Drain: BRIDLEWOOD DRAIN **Drain #:** 66
Improvement/Arm: BRIDLEWOOD - SECTION 4
Operator: JPH **Date:** 10-30-03
Drain Classification: Urban/Rural **Year Installed:** 1992

Drain-Improvement: BRIDLEWOOD DRAIN - SECTION 4

RE: Bridlewood Drain-Section 4

CONSTRUCTION PLANS FOR BRIDLEWOOD SECTION IV

SEE SHEET 6 of 13

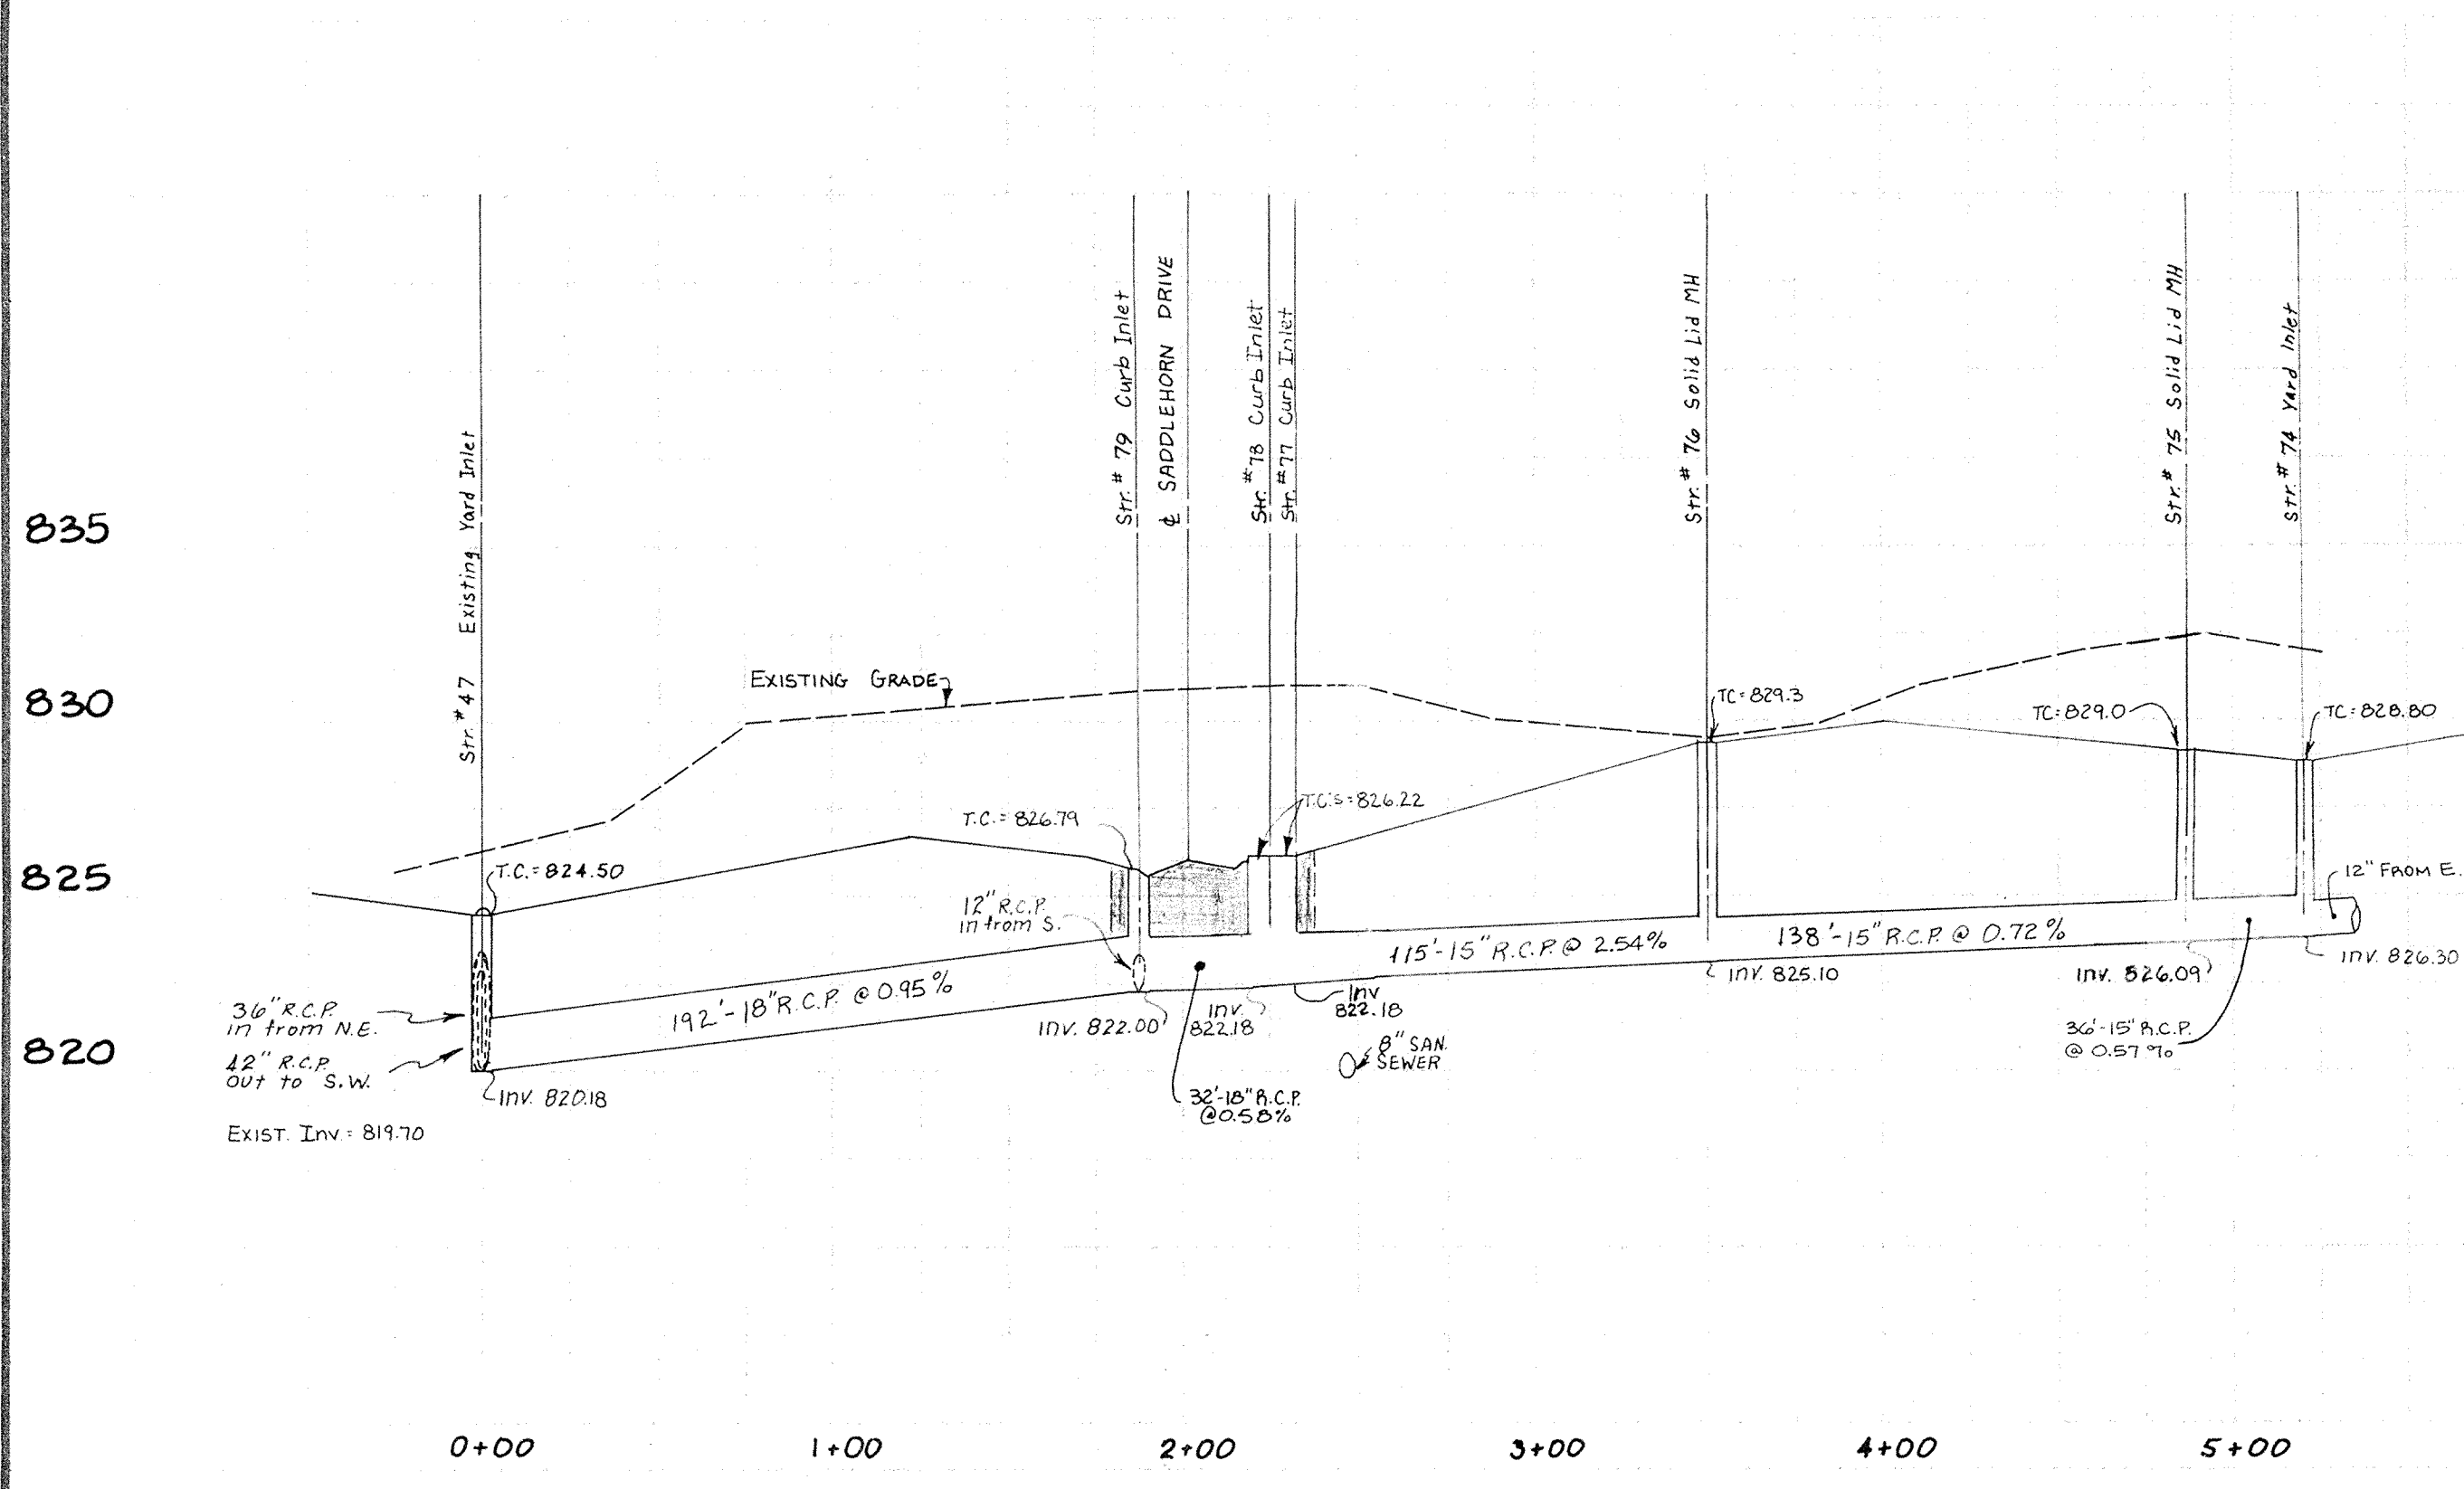
STR 79 to 80	12"	RCP	lengthened	from 44'	to 47 feet	✓
STR 73 to 72	21"	RCP	shortened	from 58'	to 53 feet	✓
STR 72 to 71	18"	RCP	shortened	from 26'	to 24 feet	✓
STR 71 to 70	18"	RCP	lengthened	from 160'	to 161 feet	
STR 67 to 68	12"	RCP	lengthened	from 155'	to 226 feet	✓
STR 74 to 75	15"	RCP	lengthened	from 36'	to 38 feet	
STR 76 to 77	15"	RCP	lengthened	from 115'	to 117 feet	
STR 78 to 79	18"	RCP	shortened	from 32'	to 31 feet	
STR 79 to 47	18"	RCP	lengthened	from 192'	to 193 feet

The six (6") inch SSD across the rear of Lots 45 through 48 and Lots 37 to 39 were replaced with twelve (12") inch RCP. The following structures and lengths were added accordingly:

STR 85 to 86	12"	RCP	at 200 feet in length
STR 86 to 69	12"	RCP	at 235 feet in length
STR 84 to 81	12"	RCP	at 89 feet in length
STR 81 to 74	12"	RCP	at 216 feet in length
STR 83 to 82	12"	RCP	at 24 feet in length
STR 82 to 81	12"	RCP	at 160 feet in length

The length of the drain due to the changes described above is now 9,650 feet.
